**RE: Savory Elementary Pedestrian Bridge  
Structural Assessment Report**

**RJC No. VIC.143561.0001**

Sketch Title  
**Existing Conditions**

Sketch Title  
**RECOMMENDED UPGRADES**

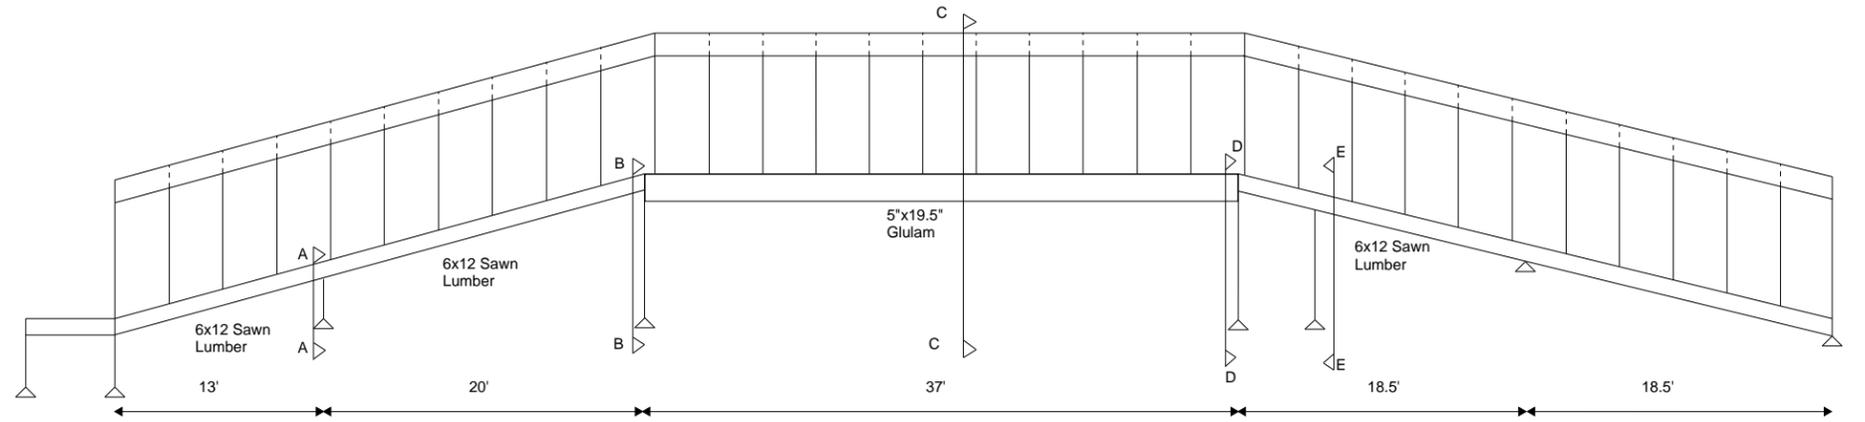
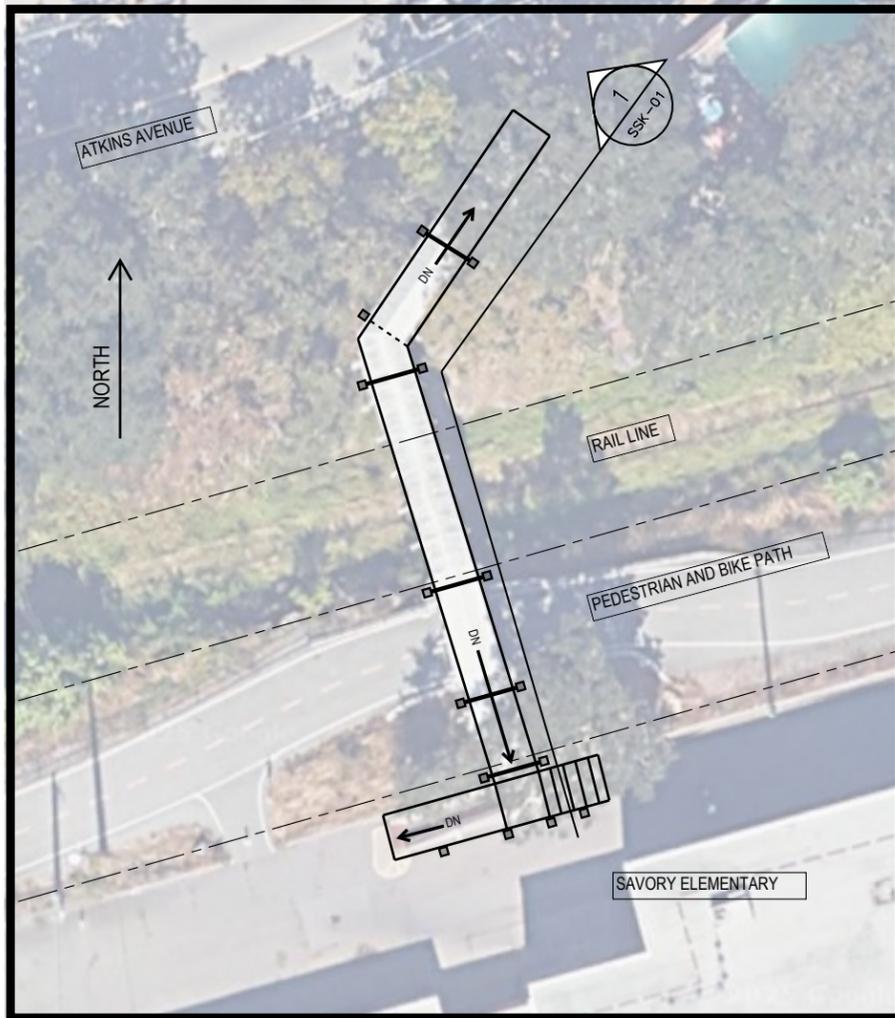
For the primary structure, the most significant concern is with the guard and picket system for the walkway. The continuous 2x4 is not a suitable top rail; the 2x4 at 610 studs has insufficient strength and is not sufficiently restrained at the top, and the chainlink does not meet code requirements for pickets. Even with the exterior bracing at 1220 o.c. in some spans, it is not believed the enclosure could resist the prescribed loading from the building code for a guard rail, indicating a falling hazard within the primary walking path.

- Remove and replace deteriorated 2x6 boards
- Remove the superstructure and re-frame with 6x6 posts, a 4x4 top rail, and code complaint pickets
- Re-frame a new roof with a plywood diaphragm. This could be trusses or site-built framing

Dwg. Ref. **N/A**  
Scale **AS NOTED**  
Date **2025/12/09**  
Project No. **VIC.143561.0001**  
Sketch Number  
**SSK-01**

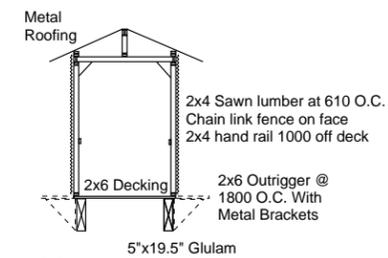
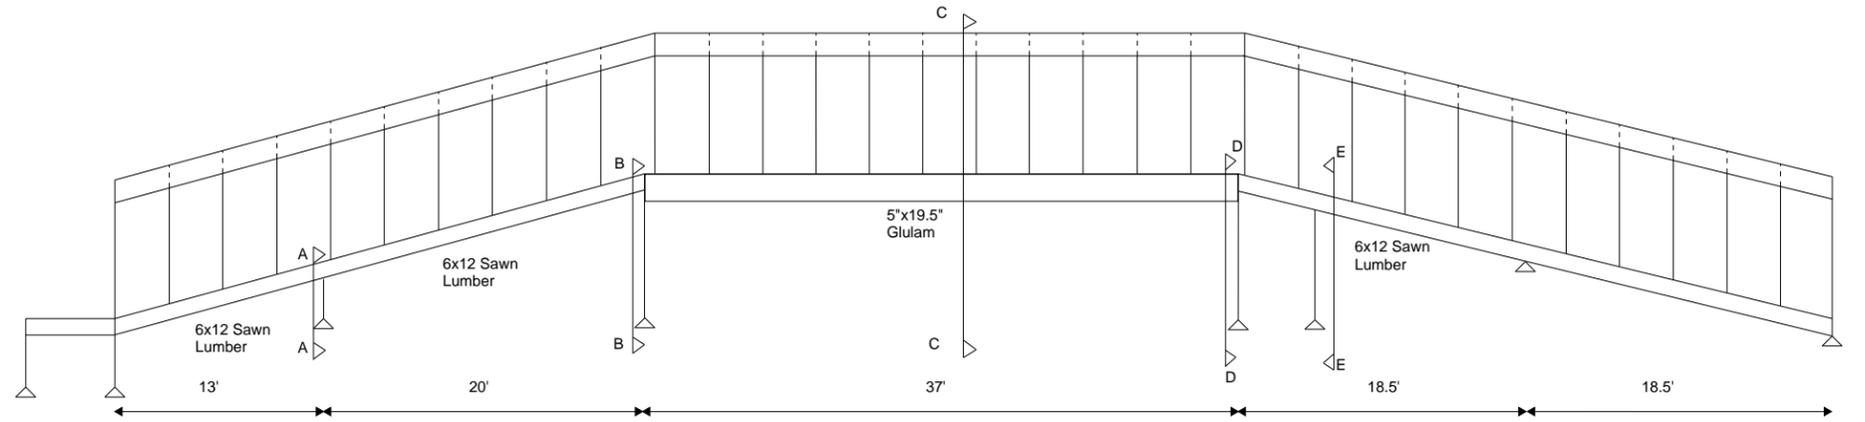
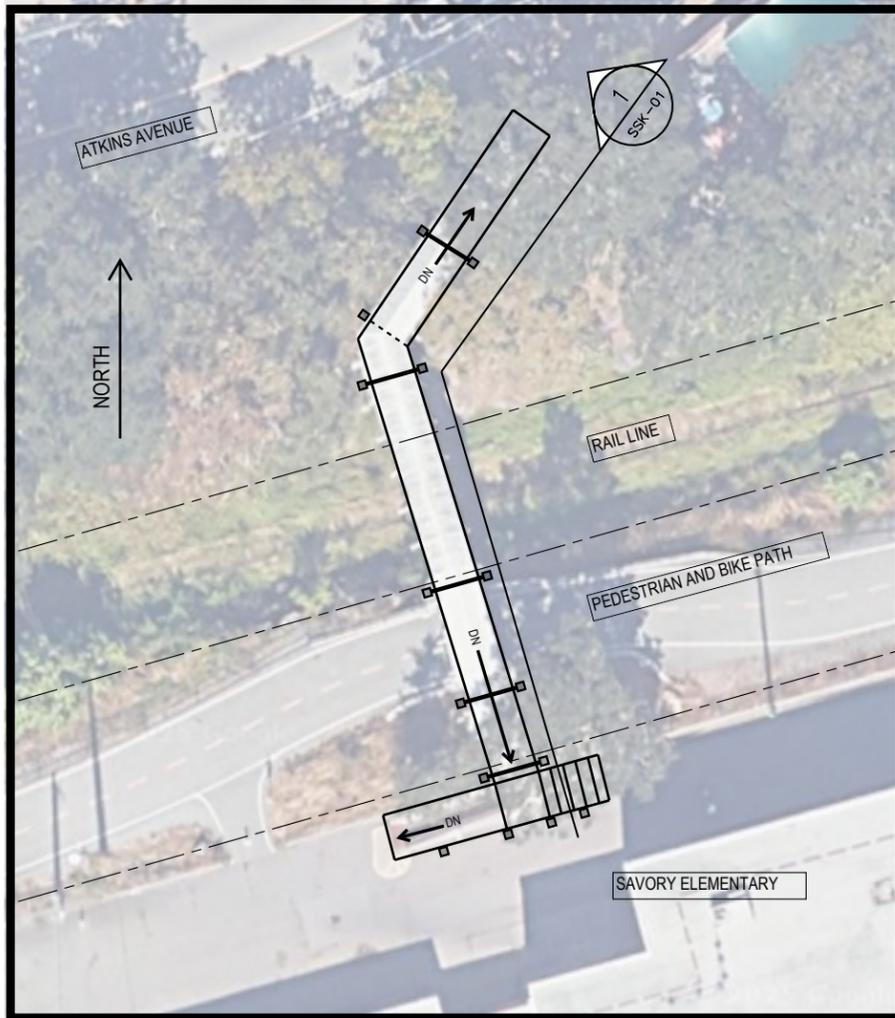
1. UPGRADE THE SUPER STRUCTURE OF THE PRIMARY SPAN TO BE A FULLY CODE COMPLIANT GUARD RAIL SYSTEM.
2. REMEDIATE DETERIORATED ELEMENTS, PRIMARILY THE DECKING OF THE MAIN SPAN.
3. IMPROVE THE OVER SEISMIC SAFETY OF THE STRUCTURE.

NOT A STRUCTURAL CONCERN THE BRIDGE APPEARS TO HAVE ISSUES WITH ACCESSIBILITY WITH THE STEEP ANGLE OF SOME OF THE RAMPS. CODE COMPLIANCE REVIEW BY AN ARCHITECT IS RECOMMENDED.

Dwg. Ref. **N/A**  
Scale **AS NOTED**  
Date **2025/12/09**  
Project No. **VIC.143561.0001**  
Sketch Number  
**SSK-02**

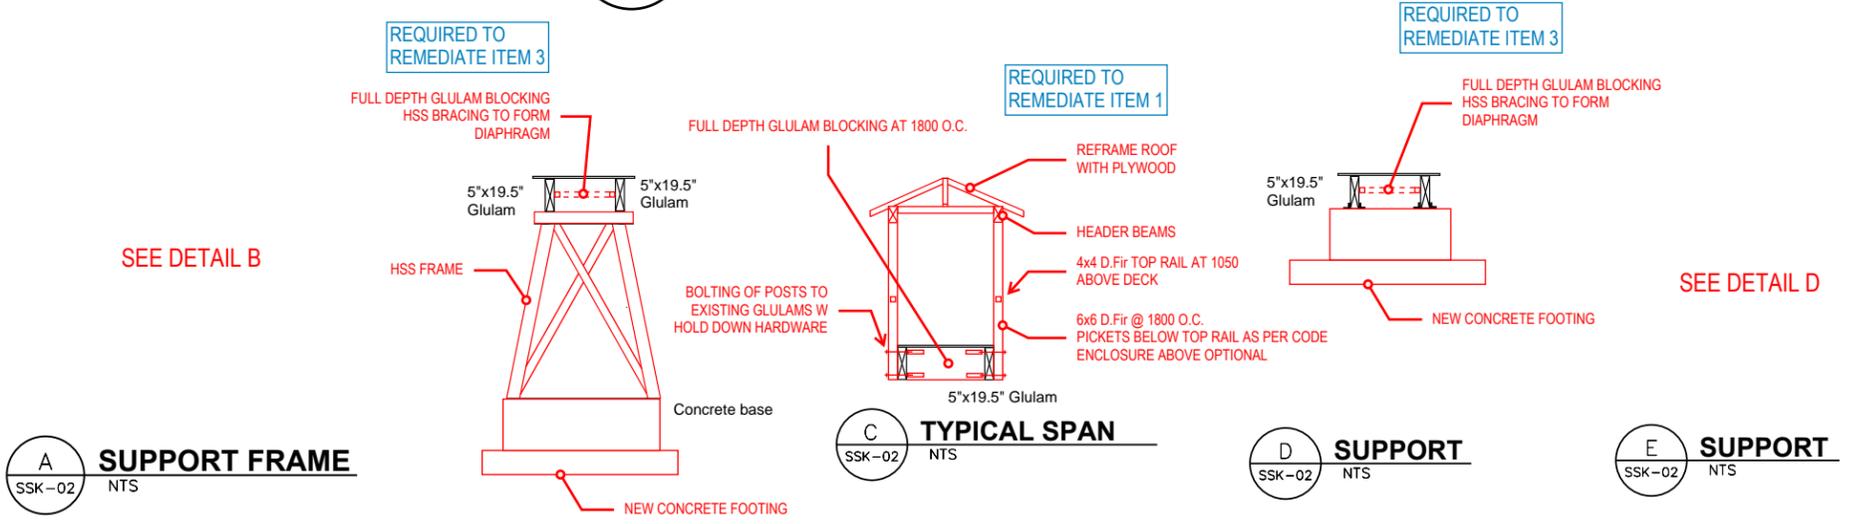
1. UPGRADE THE SUPER STRUCTURE OF THE PRIMARY SPAN TO BE A FULLY CODE COMPLIANT GUARD RAIL SYSTEM.
2. REMEDIATE DETERIORATED ELEMENTS, PRIMARILY THE DECKING OF THE MAIN SPAN.
3. IMPROVE THE OVER SEISMIC SAFETY OF THE STRUCTURE.

NOT A STRUCTURAL CONCERN THE BRIDGE APPEARS TO HAVE ISSUES WITH ACCESSIBILITY WITH THE STEEP ANGLE OF SOME OF THE RAMPS. CODE COMPLIANCE REVIEW BY AN ARCHITECT IS RECOMMENDED.

- Install HSS diagonal bracing between the glulam beams below the decking to form a diaphragm
- Replace each pier with a purpose-built seismic frame of HSS steel sections. This would likely require new footings but could be done one frame at a time while shoring up the remaining bridge.
